Discontinuation Notice of Small Limit Switch Model D4V series.**Product Discontinuation**

Small Limit Switch

**Recommended Replacement***

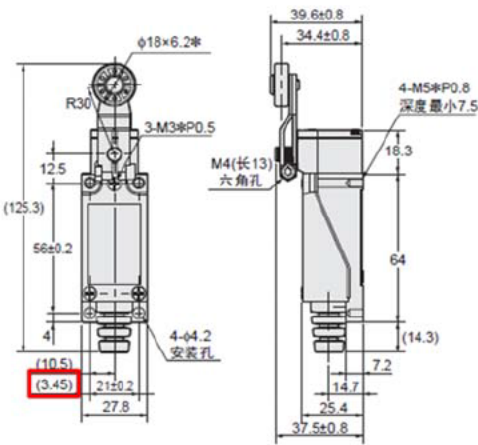
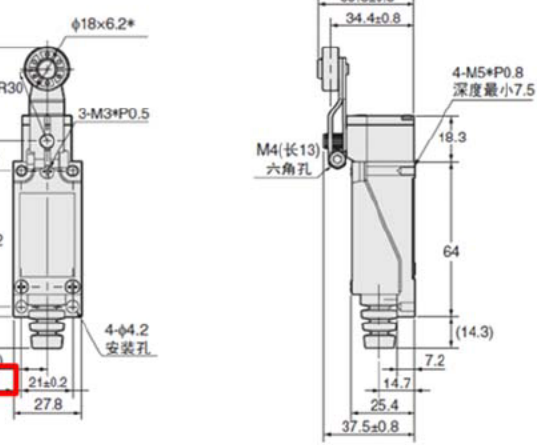
Product discontinuation	Recommendable replacement
D4V-8104Z Resin roller 	D4V-8104Z-N Resin roller 
D4V-8104SZ Solid metal roller 	D4V-8104SZ-N Hollow metal roller

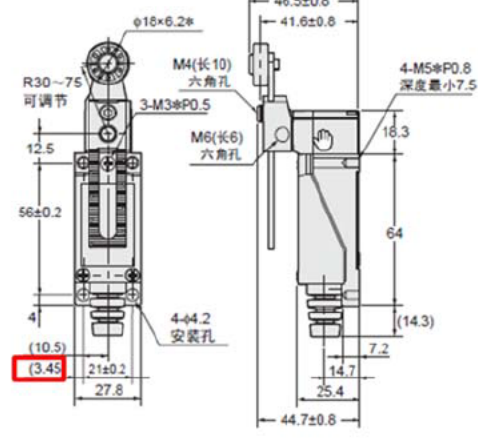
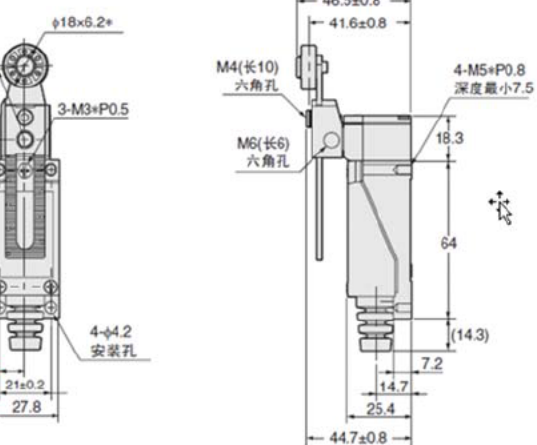
Product discontinuation	Recommendable replacement
D4V-8108Z Black anti-slip sheet Gray adjustment table 	D4V-8108Z-N Sliver anti-slip sheet Sliver adjustment table

D4V-8108SZ
Black anti-slip sheet
Gray adjustment table
Solid roller

D4V-8108SZ-N
Sliver anti-slip sheet
Sliver adjustment table
Hollow roller

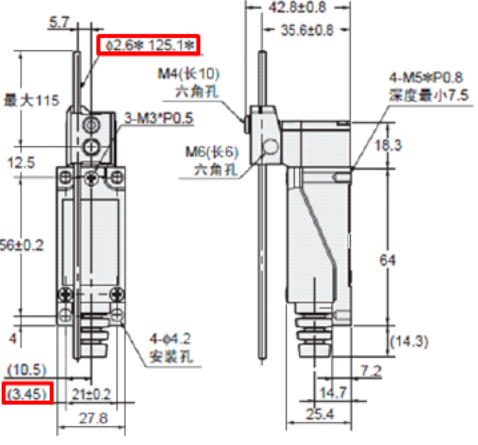
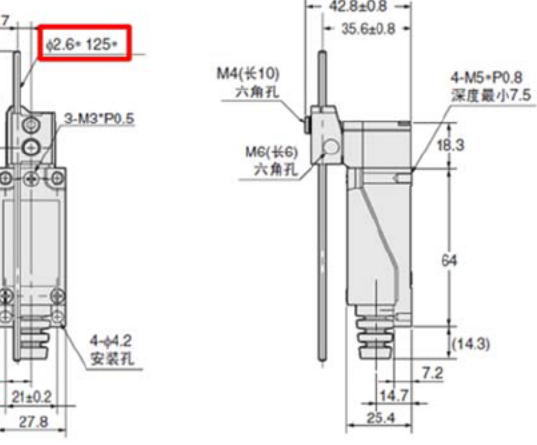
D4V-8107Z
Black anti-slip sheet
Gray adjustment table

D4V-8107Z-N
Sliver anti-slip sheet
Sliver adjustment table
